DEVELOPMENT ASSESSMENT REPORT				
Application No.	DA/2020/0147			
Address	54 Birchgrove Road BALMAIN NSW 2041			
Proposal	Part demolition and alterations and additions to existing heritage listed terrace-house and associated works			
Date of Lodgement	04 March 2020			
Applicant	Jonathan Phillips			
Owner	Mr Jonathan CH Phillips Ms Lisa M McKimmie			
Number of Submissions	Initial: 1			
Value of works	\$978,703.00			
Reason for determination at Planning Panel	Clause 4.6 variation exceeds officer delegation			
Main Issues	FSR Breach Site Coverage Breach Landscaped Area Breach Heritage and Design			
Recommendation	Approval with Conditions			
Attachment A	Recommended conditions of consent			
Attachment B	Plans of proposed development			
Attachment C	Clause 4.6 Exception to Development Standards			
Attachment D	Statement of Heritage Significance

This report is an assessment of the application submitted to Council for partial demolition and alterations and additions to a heritage listed terrace-house and associated works at 54 Birchgrove Road, Balmain.

SECTION 01
1:100

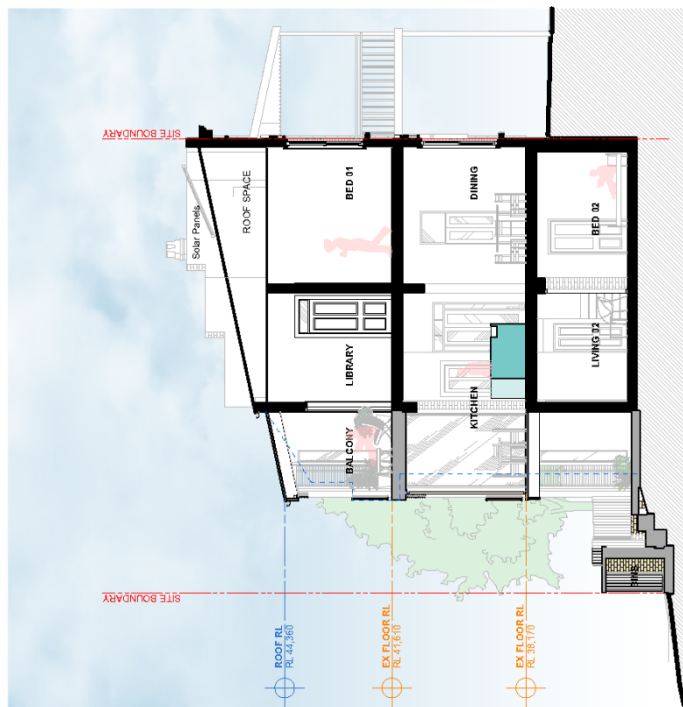
- Drawing 'Section 01' shows that the solar panels are raised above the main skillion roof form. They must be installed so they sit flush with the main skillion roof form of the heritage item to reduce their visual impact when view from the public domain; a condition is included in Appendix A;
